City of San Leandro
Civic Center, 835 E. 14th Street
San Leandro, California 94577

WPCP REHABILITATION PROJECT
PROJECT NO. 08-593-52-239

ADDENDUM NO. 1

March 7, 2011

Sketch 1.01 Contract DWG 90-S-05, Detail 11

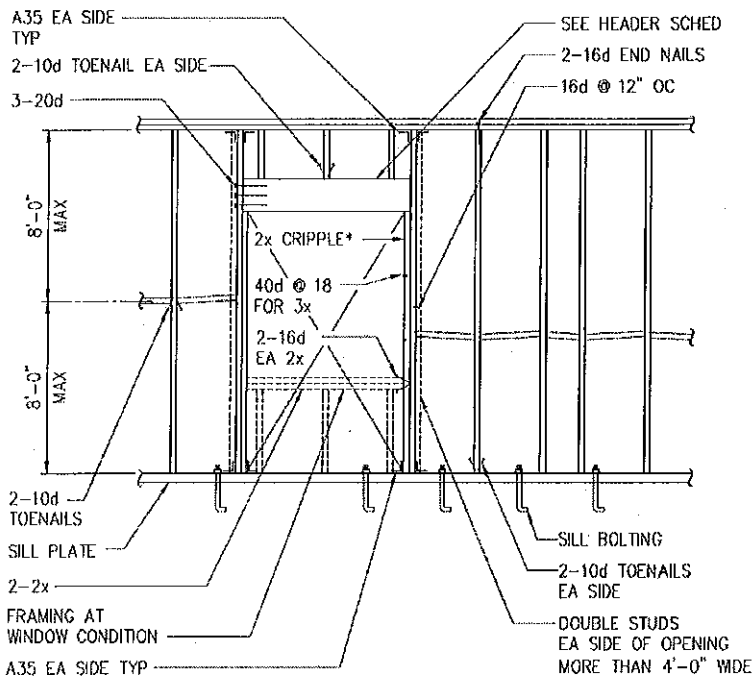
Item 1.83 **Drawing 90-S-05, Details 11** -- Delete detail 11 - DWG 90-S-05 and replace with revised detail included herewith on Sketch 1.01.

Sketch 1.02 **Contract DWG 90-S-16, Detail 5**

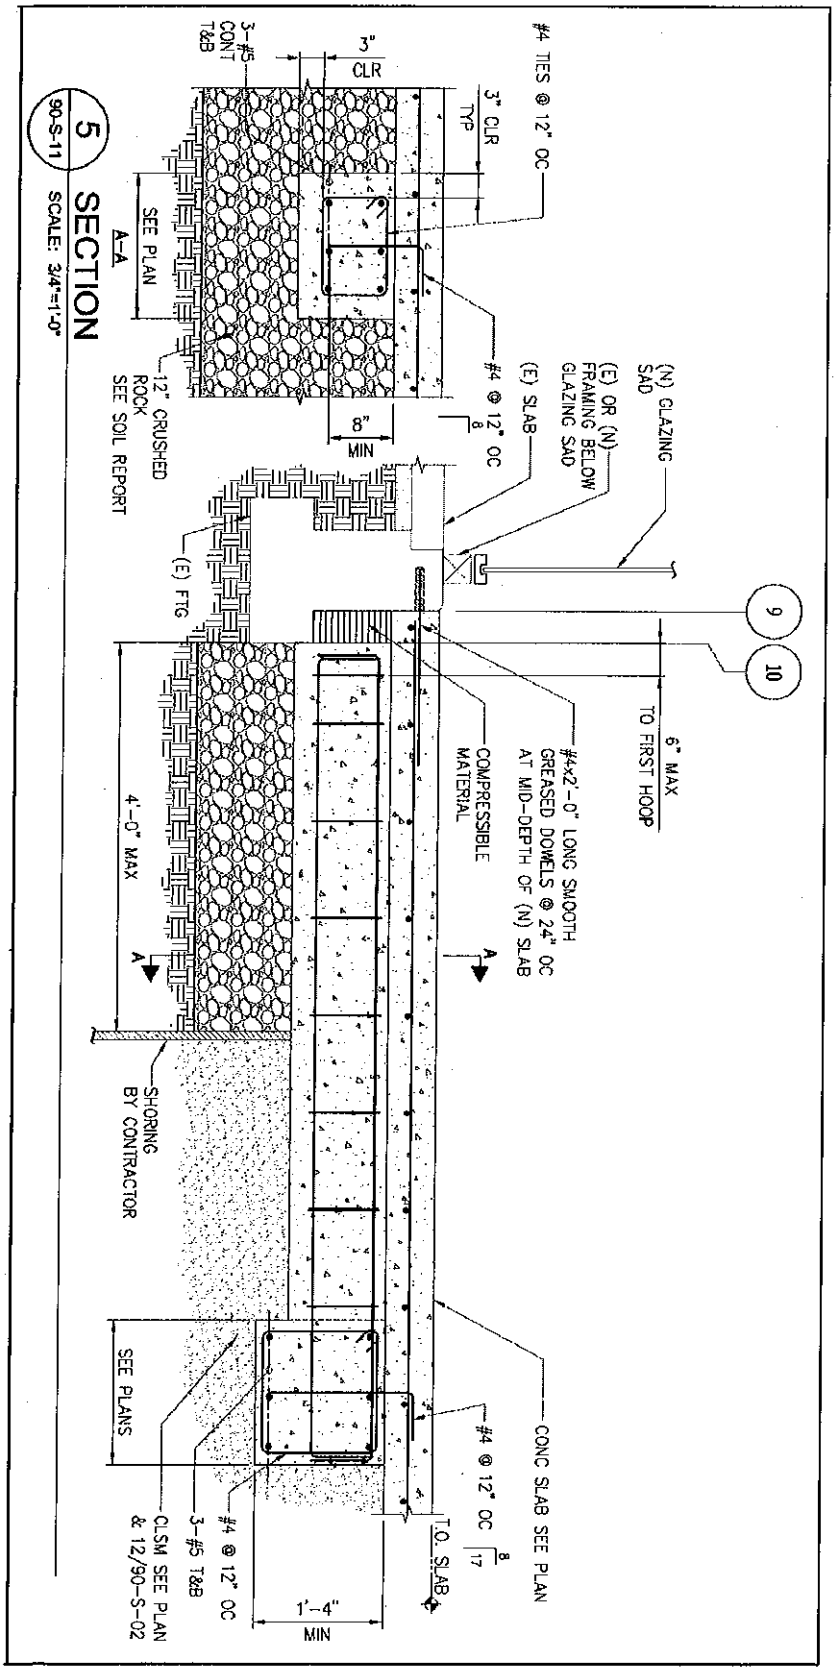
Item 1.91 **Drawing 90-S-16, Detail 5** -- Delete detail 5 - DWG 90-S-16 and replace with revised detail included herewith on Sketch 1.02.

Sketch 1.03 **Contract DWG 90-S-21, Detail 3**

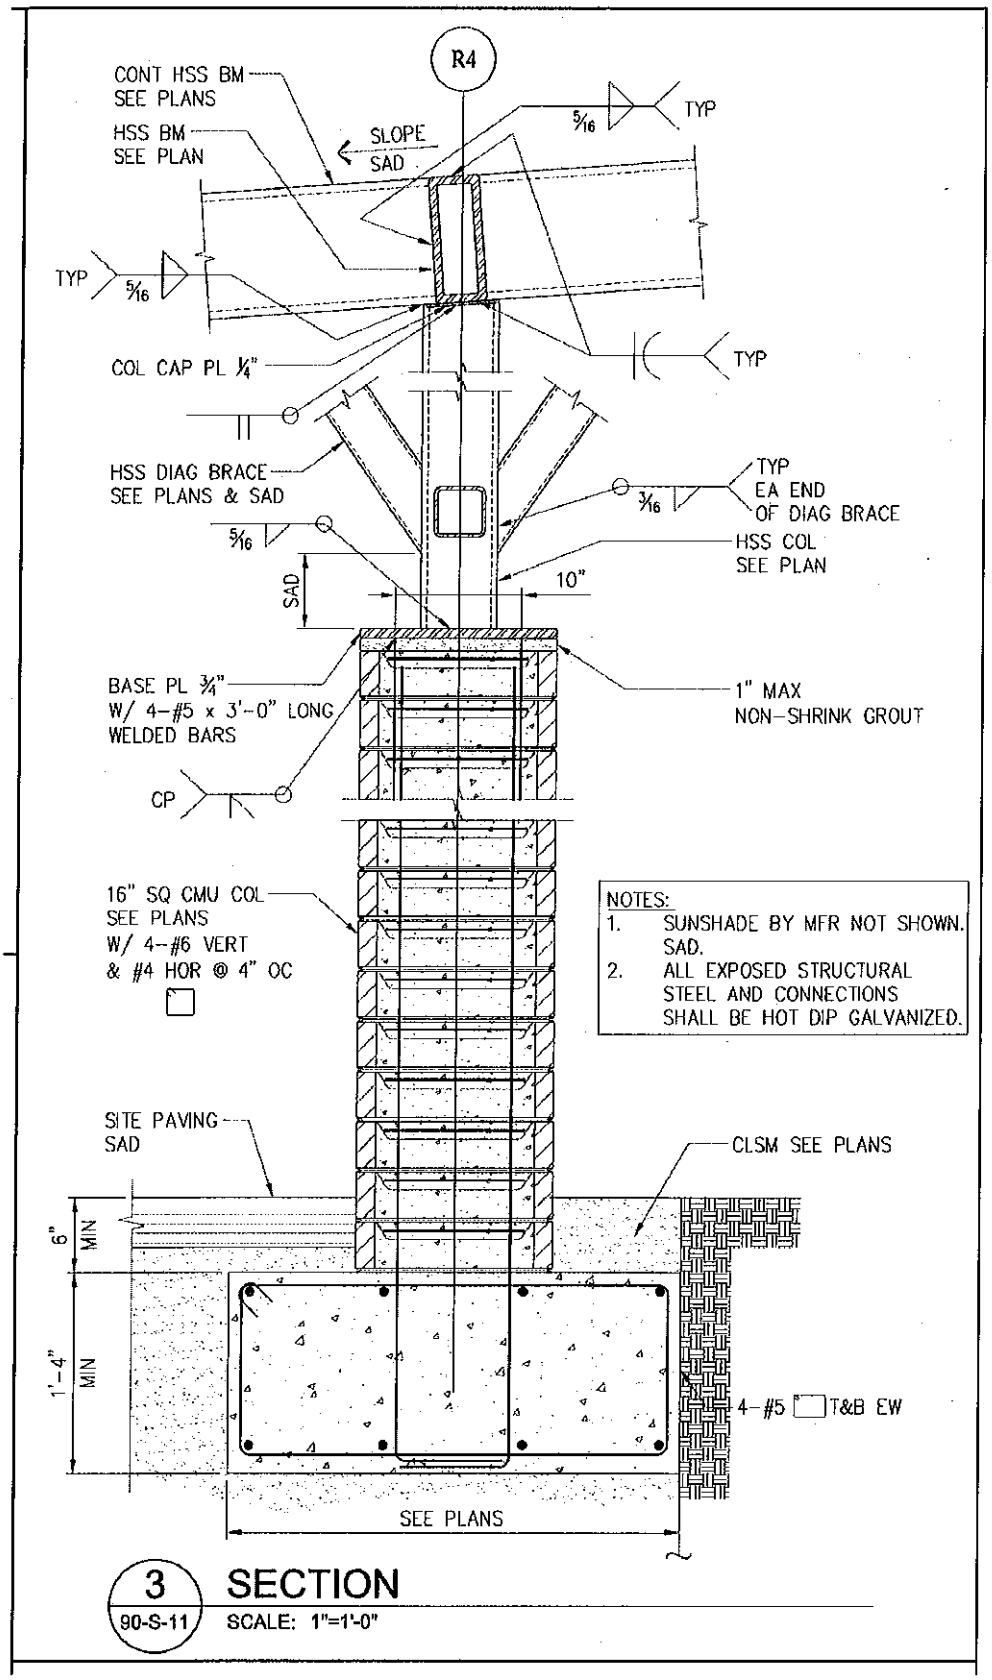
Item 1.92 **Drawing 90-S-21, Detail 3** -- Delete detail 3 - DWG 90-S-21 and replace with revised detail included herewith on Sketch 1.03.

Sketch 1.04 **Contract DWG 90-S-22, Detail 1**

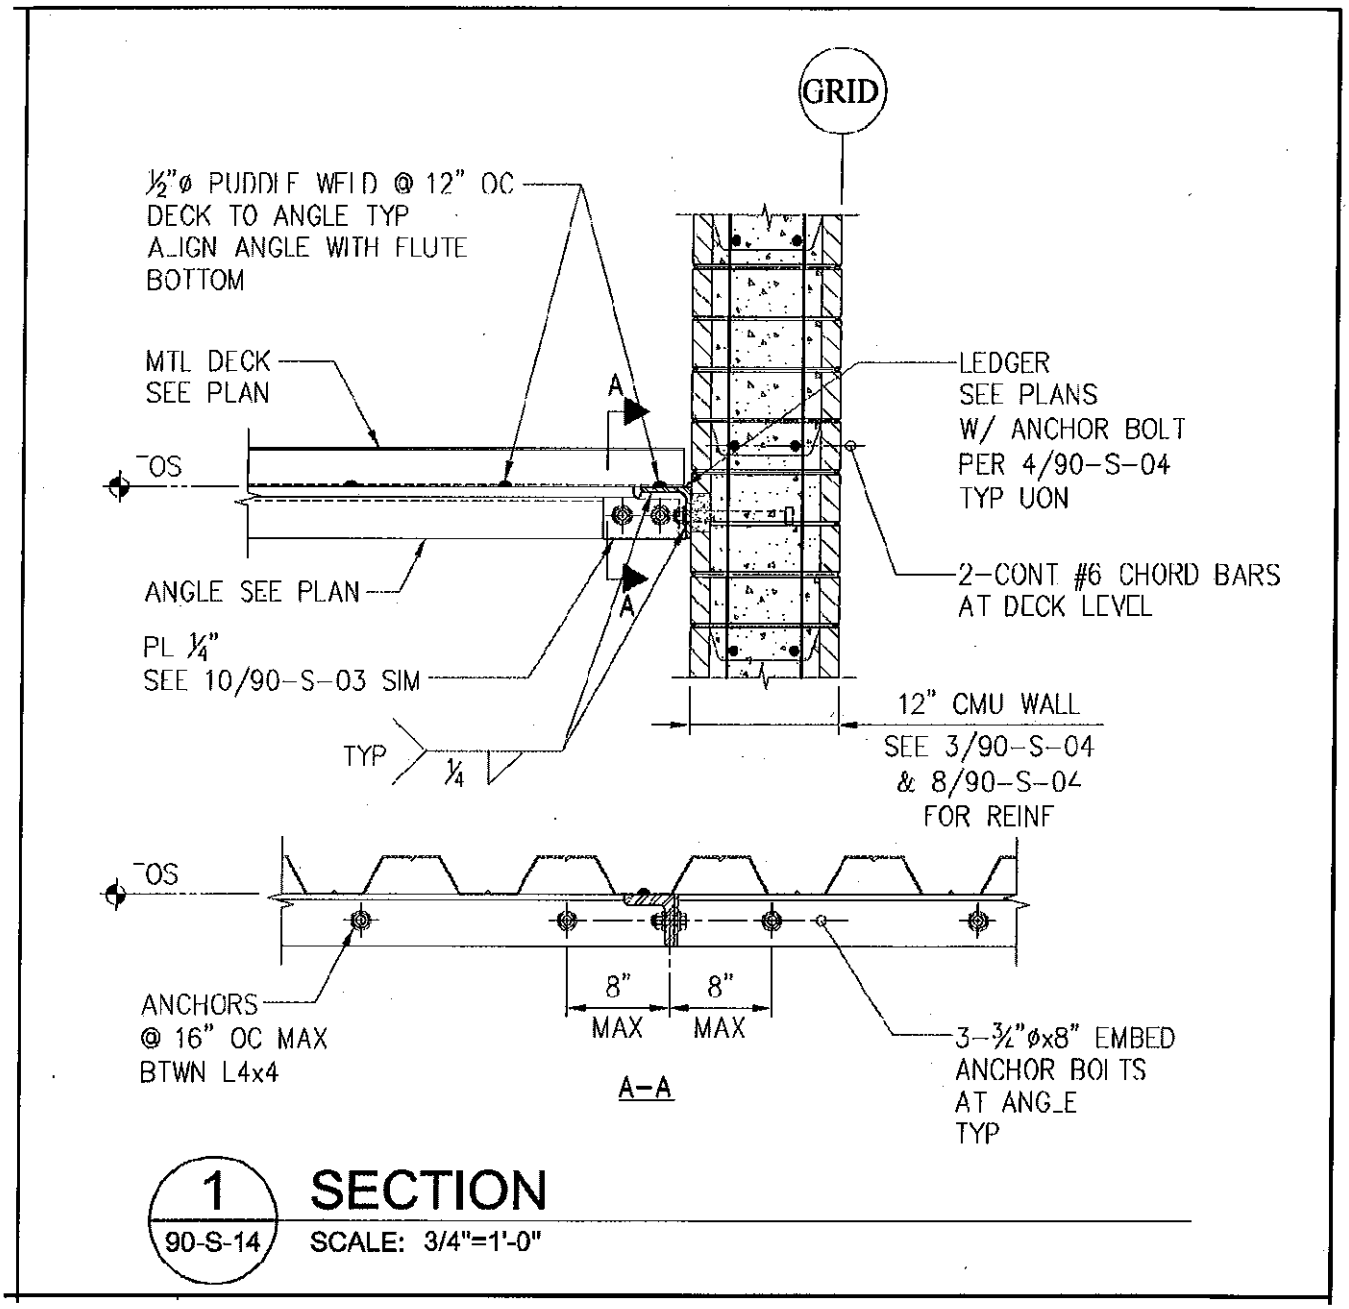
Item 1.93 **Drawing 90-S-22, Detail 1** -- Delete detail 1 - DWG 90-S-22 and replace with revised detail included herewith on Sketch 1.04.

Sketch 1.05 **Contract DWG 90-S-22, Detail 3**

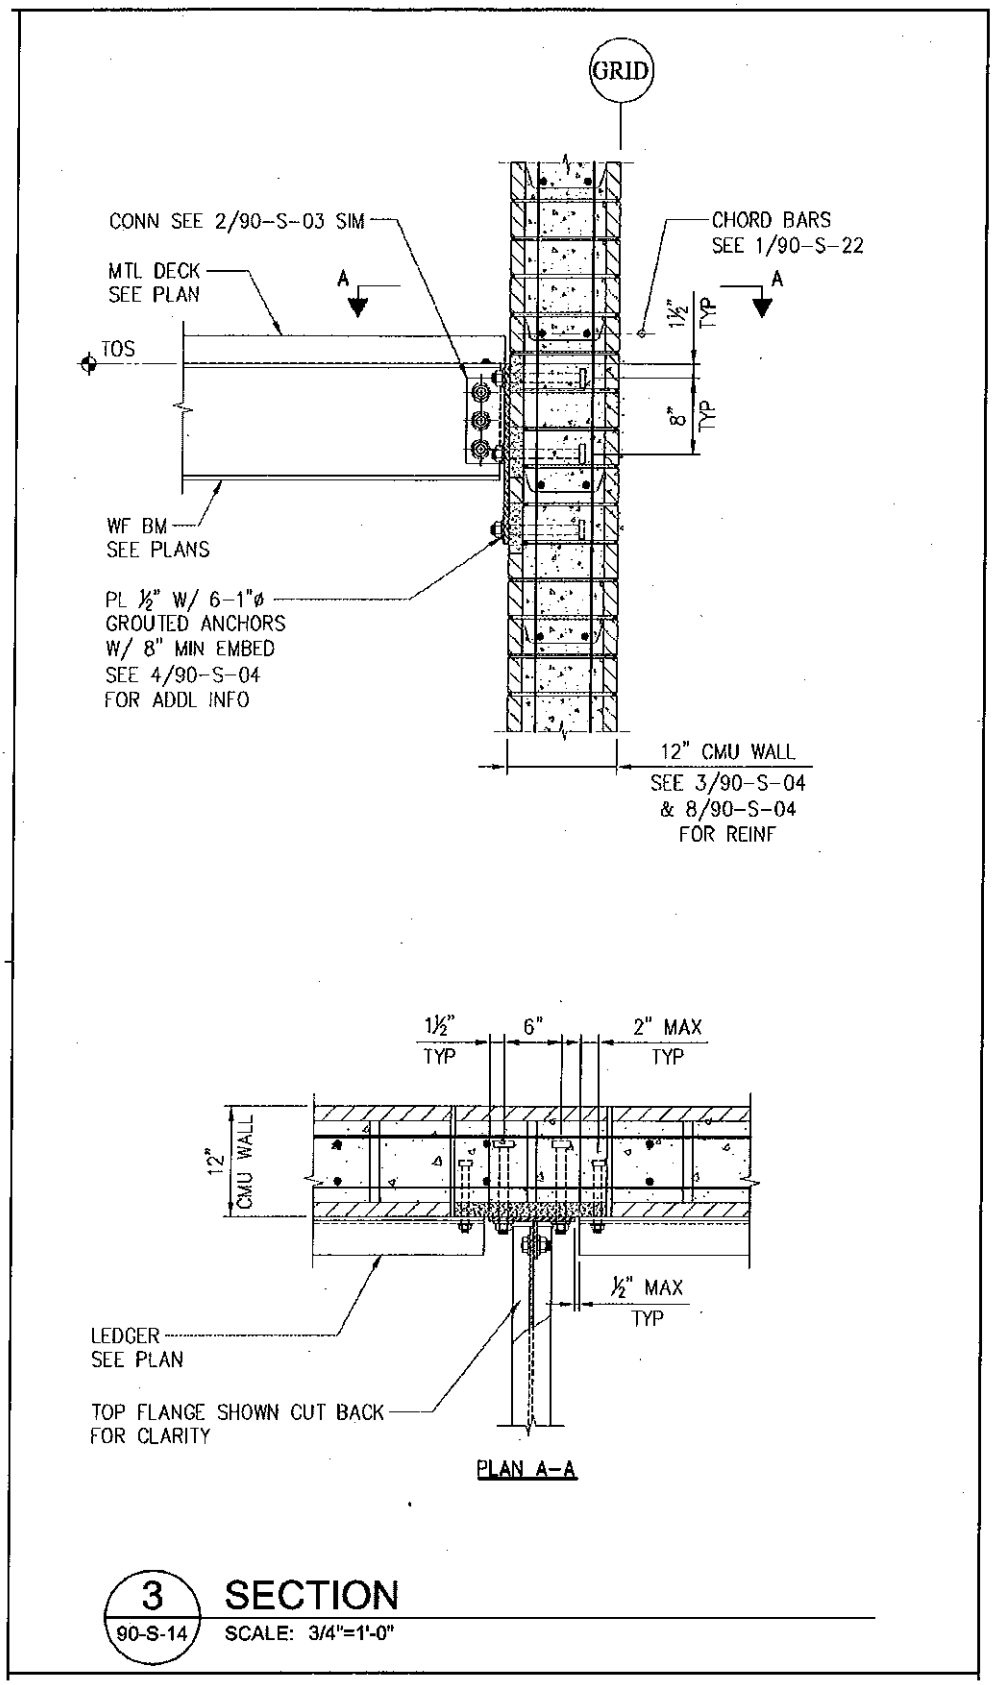
Item 1.94 **Drawing 90-S-22, Detail 3** -- Delete detail 3 - DWG 90-S-22 and replace with revised detail included herewith on Sketch 1.05.
